City of Mississauga Department Comments

Date Finalized: 2024-04-10	File(s): A166.24 Ward: 11
To: Committee of Adjustment	
From: Committee of Adjustment Coordinator	Meeting date:2024-04-18 1:00:00 PM

The applicant requests the Committee to approve a minor variance to allow a below grade entrance with a side yard setback of 0.06m (approx. 0.20ft) whereas By-law 0225-2007, as amended, requires a minimum side yard setback of 1.20m (approx. 3.94ft) in this instance.

Property Address: 6741 Historic Trail

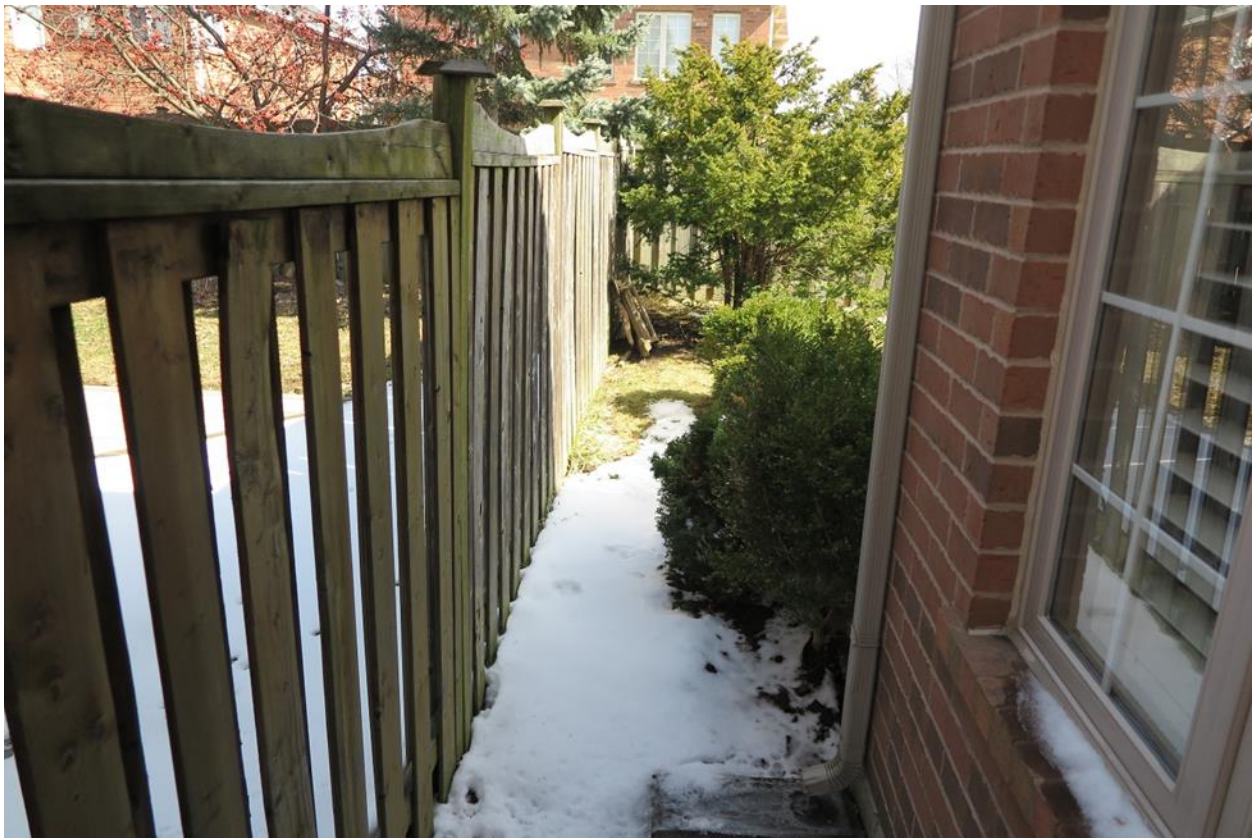
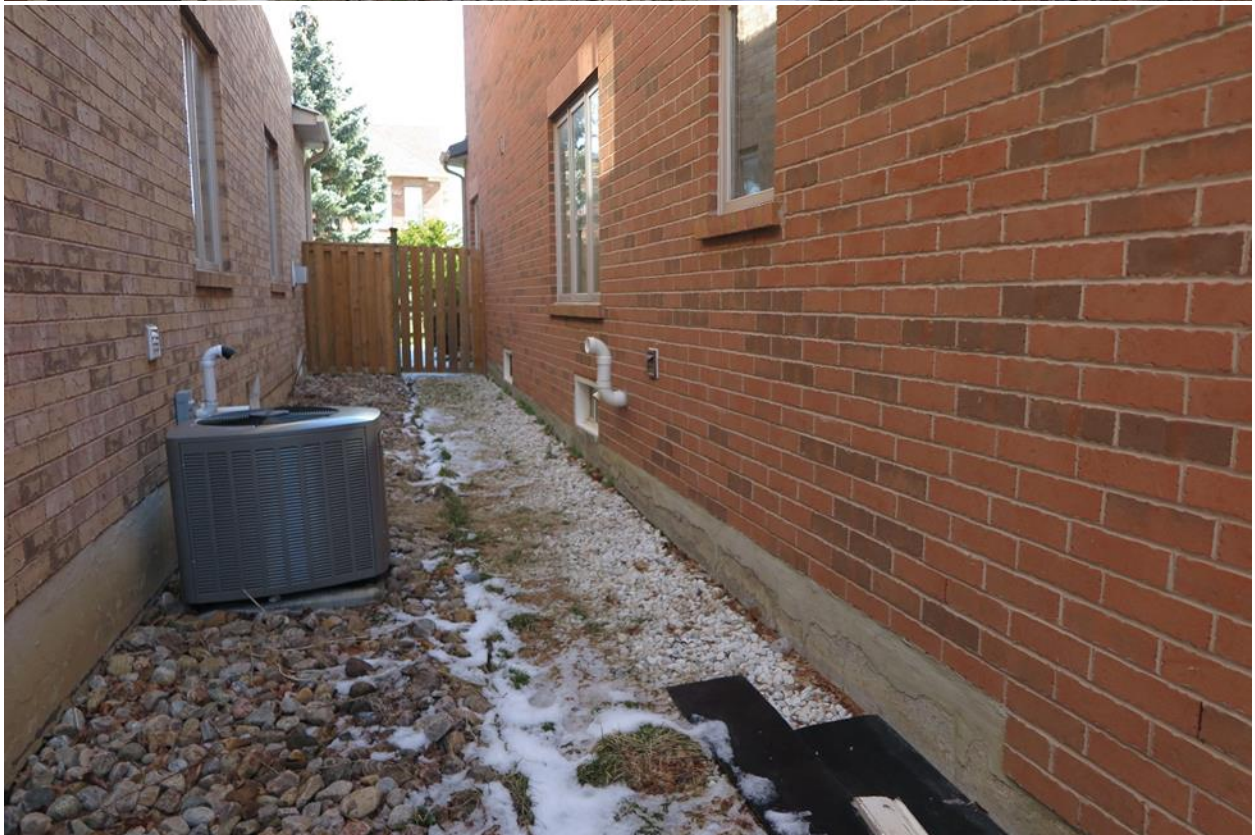
Enclosed for Committee's information are some photos which depict the area where the proposed side entrance is being proposed. We note that the Grading Plan (Plan C-43163) approved for this property under Registered Plan of Subdivision 43M-1395 depicts a rear to front drainage pattern meaning drainage from the rear yard was designed to be directed to the front via side yard swale.

The requested reduction in the side yard setback significantly reduces the side yard setback and this would not allow for a fully functional drainage swale between the properties resulting in some drainage being directed onto the adjacent property. Should the Committee see merit in the applicant's request, we would recommend that the existing drainage pattern in the area of the proposed side stairwell be maintained by narrowing the stairwell so that the foundation wall is offset a minimum of approximately 6 inches/0.15m from the property line.
